SYDNEY SOUTH PLANNING PANEL

Panel Reference	2017SSH038
DA Number	DA17/1307
LGA	Sutherland Shire
Proposed Development:	Demolition of existing structures and construction of 21 townhouses (reduced from 22) including 5 'affordable rental housing' dwellings and 1 level of basement parking
Street Address:	Part Lot A DP 386887, Lot B DP 405057, Lot Y DP 446347, Lot 2 DP 394270, and Lot X DP 446347 - (Nos. 945-947) Old Princes Highway and (Nos. 2-4) Anzac Avenue, Engadine
Applicant/Owner:	Bechara Chan & Associates Pty Ltd
Date of DA lodgement	26 September 2017
Number of Submissions:	9
Recommendation:	Approval
Regional Development Criteria (Schedule 4A of the Act)	Affordable Rental Housing Exceeding \$5 million
List of all relevant s79C(1)(a) matters	<ul style="list-style-type: none"> • State Environmental Planning Policy (State and Regional Development) 2011 • State Environmental Planning Policy (Affordable Rental Housing) 2009 (ARHSEPP) • State Environmental Planning Policy (Infrastructure) 2007 • State Environmental Planning Policy (Building Sustainability Index: BASIX) 2004 • State Environmental Planning Policy No. 55- Remediation of Land (SEPP 55) • Greater Metropolitan Regional Envi

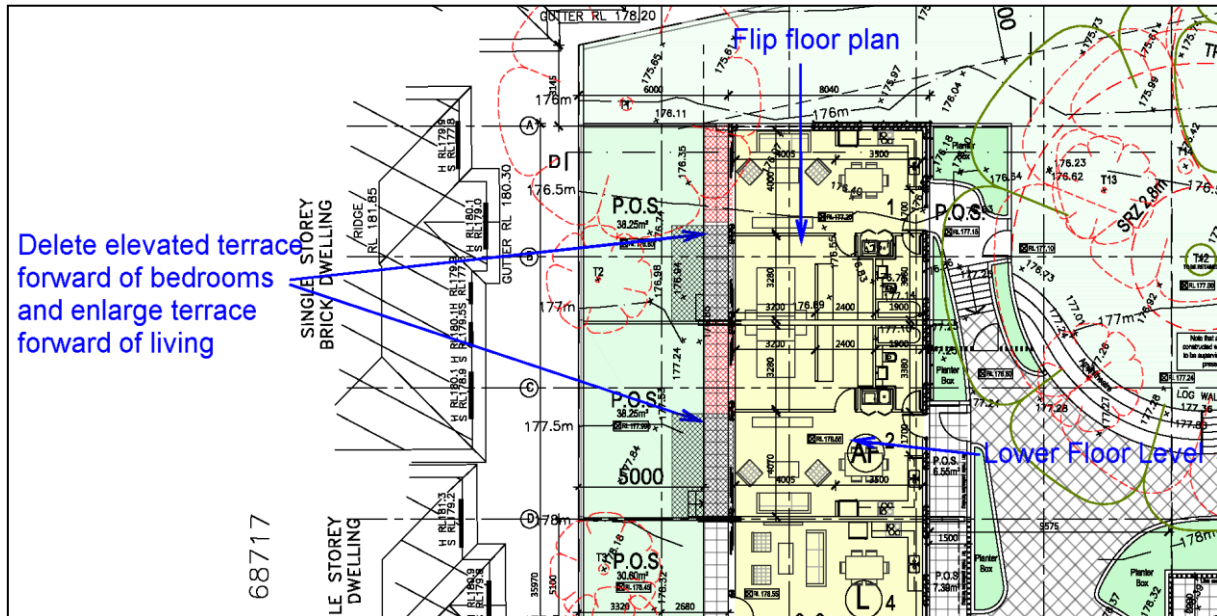
The building setbacks and frontage design (including fencing strategy) along the Princes Highway does not comply in full with the provisions of SSDCP2015. Whilst articulation / variation is provided to the fencing allowing for plantings forward (which is an appropriate response to the streetscape) the 1.5m high solid masonry fencing elements located on the boundary are ordinarily required to be maintained as open form or alternatively setback 1.5 from the boundary in full to allow for landscaping. A defensive presentation to the Princes Highway is considered appropriate and anticipated to enhance acoustic amenity to future occupants. Refinement of the fencing strategy (including finishes) is however required to enable appropriate streetscape presentation and suitable area for planting forward. The final fence design will be well articulated and respond appropriately to the splayed nature of the site and proposed building form. The design changes are detailed in Condition 2 of **Appendix "A"** and detailed on the plans in **Appendix "E"**.

There is also a point encroachment of Dwelling 7 (at 2m setback) within the required 3m secondary street setback given the splayed nature of the boundary to the building form, massed parallel to the southern boundary. The southern portion of the front façade is setback greater than the required 3m and responds well with the established streetscape character. The development as a whole is modulated / articulated providing a stepped response to the street edge. The proposal adequately satisfies the objectives of the development control and the minor variation is supported.

The setback to the entry pergola on Anzac Avenue projects forward of the 7.5m building alignment. The structure is generally light-weight and open form and assists in way-finding and directing residents and visitors to the site entry. The setback is recommended to be increased to 4m to further reinforce the objectives of the development control and spatial proportions of the street, as well as increasing visibility for drivers and pedestrians at this particular location.

The driveway width needs to be increased to 8m. To ensure adequate landscaping within the frontage is maintained a suitable condition is recommended (design changes in Condition 2 of **Appendix "A"**) which requires the re-orientation of the egress stairs and increased landscape provision which will further assist in ameliorating the visual impacts of the development and to reinforce the character of the streetscape.

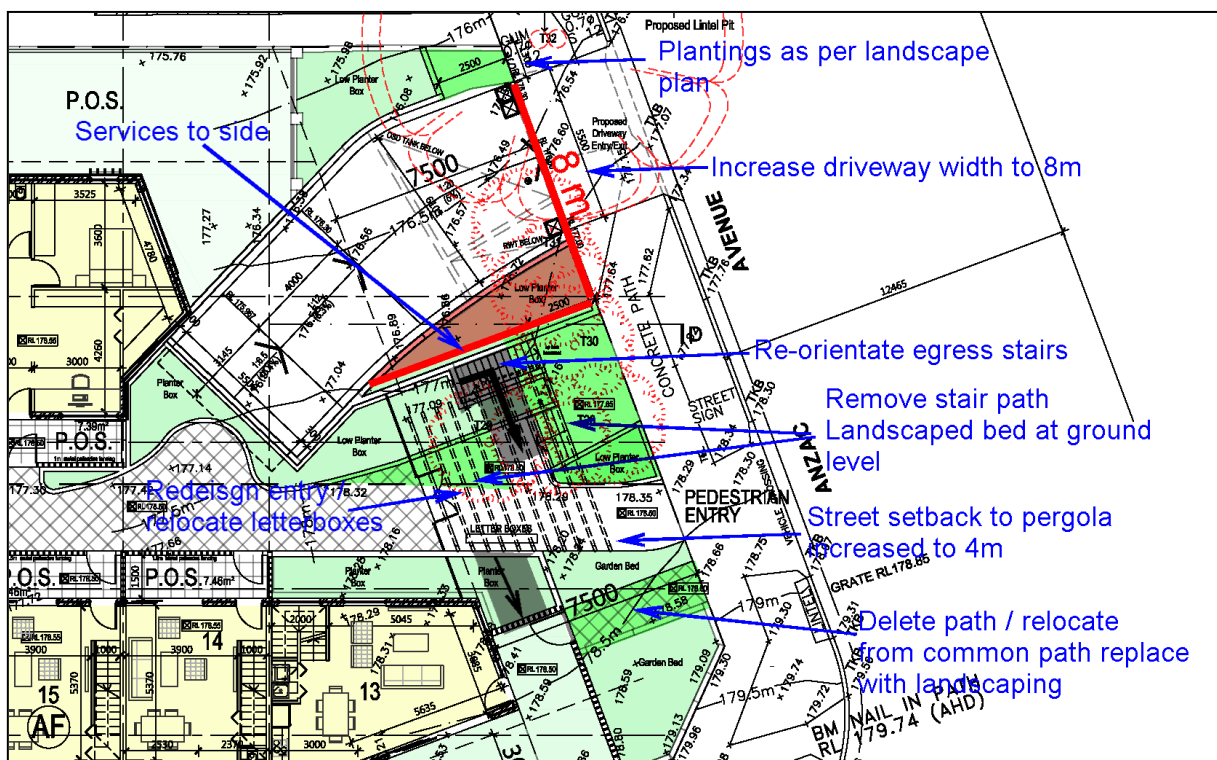
Specific concerns have been raised regarding the potential traffic impacts and parking / pedestrian conflicts within the surrounding road network associated with the increase in resident population and vehicle movements associated with the development. The adjoining Princes Highway is a heavily trafficked major arterial road under control by the Roads & Maritime Services (RMS). Anzac Avenue is a local arterial road which services the Engadine and Woronora Heights residential catchments.

The intersection, which is not controlled by traffic lights, is a known 'hot spot' for vehicular conflict and accidents. Introducing a significant number of new vehicles to the location, via a new driveway, which requires slowing and 'propping' close to the turn-off from the Highway, appears dangerous. The suitability of the site for intensive multi dwelling housing is uncertain given these factors.

To further enhance vehicular / pedestrian safety including manoeuvring into the site, vehicular queuing and sight lines the width of the driveway is to be increased from 6m to 8m and the planter bed is to be provided at existing ground level. Signage shall also be erected at the exit of the basement and arrow depicted on the driveway surface (within the property) advising residents / visitors and service vehicles to exit in a left hand direction only.
